County of Fairfax, Virginia

STAFF REPORT

APPLICATION SE 2007-MA-034

PROPOSAL: Develop a freestanding drive-in financial institution with two, detached drive-through lanes in a Highway Corridor Overlay (HC) District; and waivers and modifications in a Commercial Revitalization District (CRD).

SHEET TITLE: BUILDING ELEVATIONS
 SHEET NUMBER: 8
 OF 10

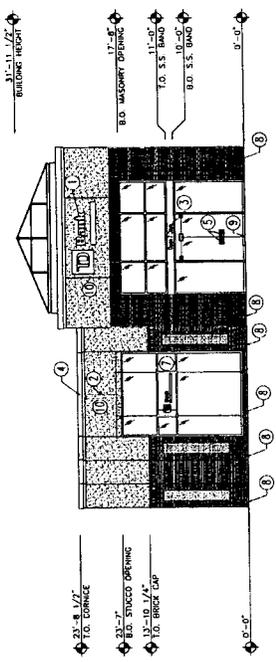
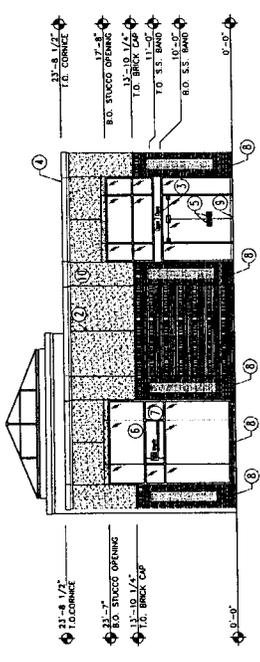
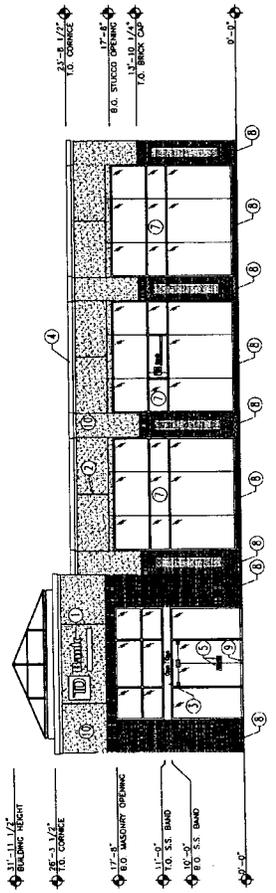
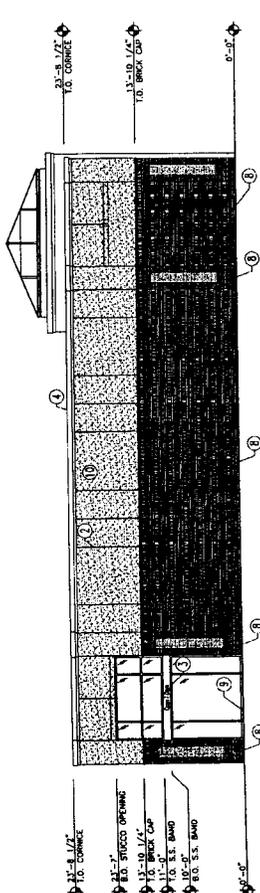
- *Architecture:* Sheet 8 of the SE Plat depicts the proposed building with architectural details shown on all four facades. The notes indicate that the building materials will consist of brick, stucco and spandrel glass, topped with a cast stone cornice. The pillars along the outside edge of the drive-through canopy are shown to be constructed with materials similar to the main building. A canopy is shown extending entirely over the northern-most drive-thru lane and a section of the second lane to the south.

- *Signage:* the SE Plat shows a free-standing monument sign to be located in the vegetated area at the corner of Little River Turnpike and Backlick Road. Sheet 8 shows wall-mounted signage consisting of internally illuminated, green individual letters over each building entrance; one facing Little River Turnpike and the other facing Backlick Road. Green "TD" door pulls are on each door entrance. Green illuminated signage with the "TD Bank" logo is shown suspended from the open glass areas on the north, east and west sides of the building.

SHEET NO. 9
 OF 10
 SIGHT DISTANCE PLAN AND PROFILE-BOCKLE ROAD
 STREET NUMBER

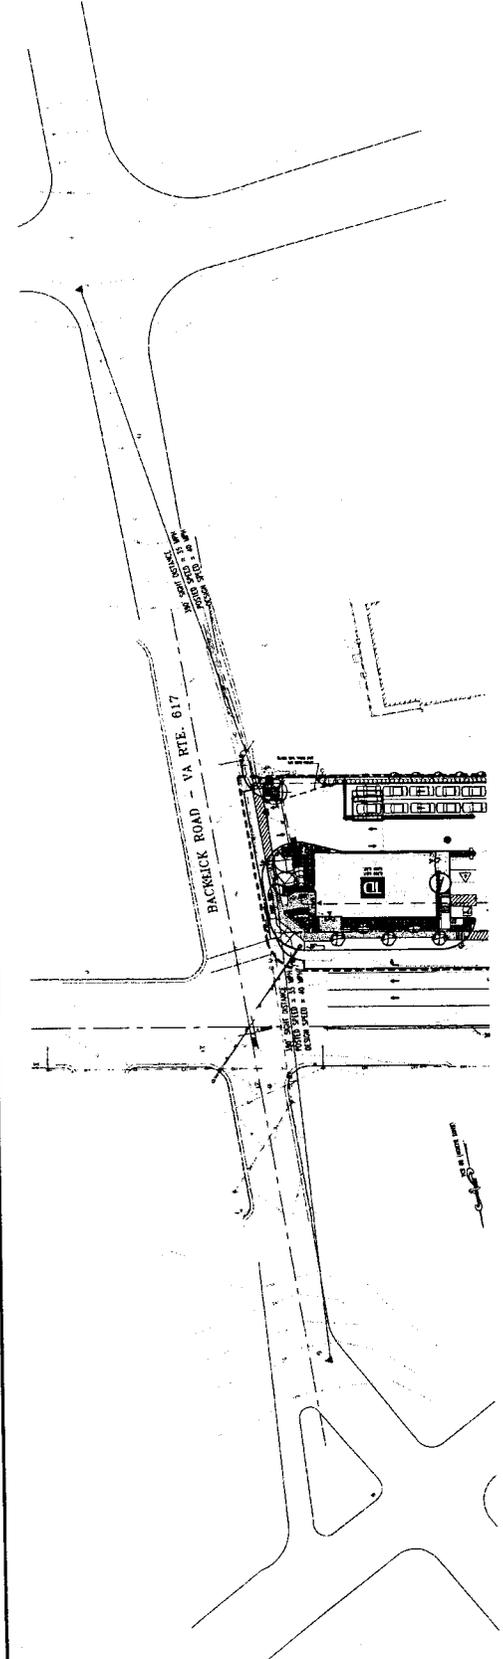
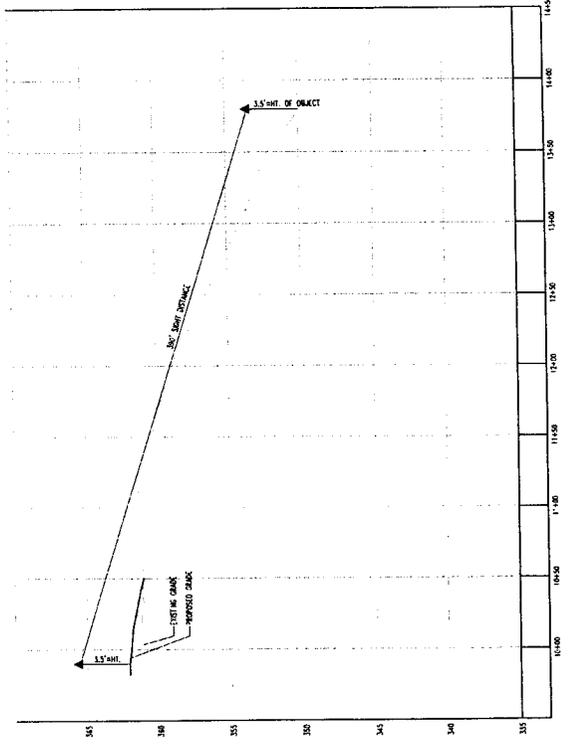
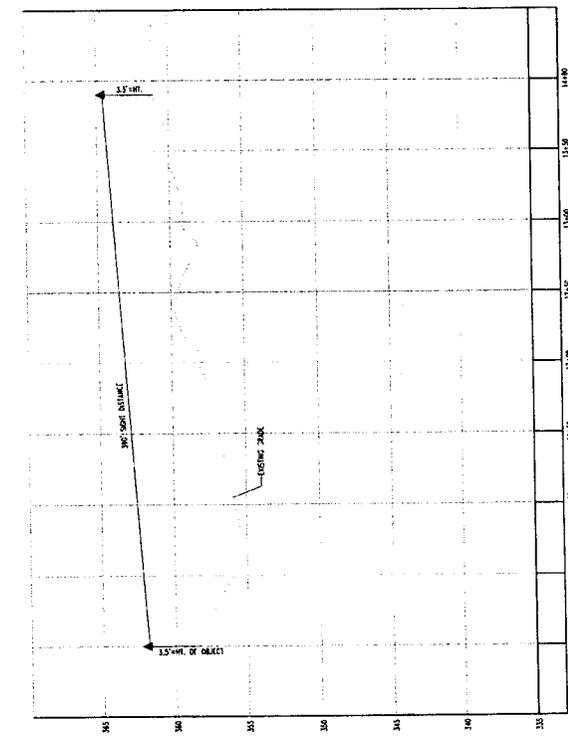
Staff has noted that the vegetation depicted on the SE Plat conflicts with sight distance lines at the Backlick Road entrance. This vegetation must either be removed or relocated to avoid sight distance conflicts. The sight distance exhibit shown on Sheet 10 of the SE Plat for the entrance onto Little River Turnpike is incorrect and must be revised to show the sight distance for the Little River Turnpike entrance to depict both its current condition and as it would appear after the planned road widening is implemented. This concern remains outstanding, but Staff has proposed a development condition that requires the applicant to demonstrate that the site meets appropriate sight distances at all entrances, including the removal or relocation of any vegetation which poses a conflict, prior to site plan approval. With the adoption of this development condition, this issue is resolved.

14. An appropriate turn radius shall be provided for vehicles entering the site from Little River Turnpike. No streetscape materials shall obscure sight lines from the site entrances at Backlick Road or Little River Turnpike; plant materials shall be relocated on site as approved by UFM.
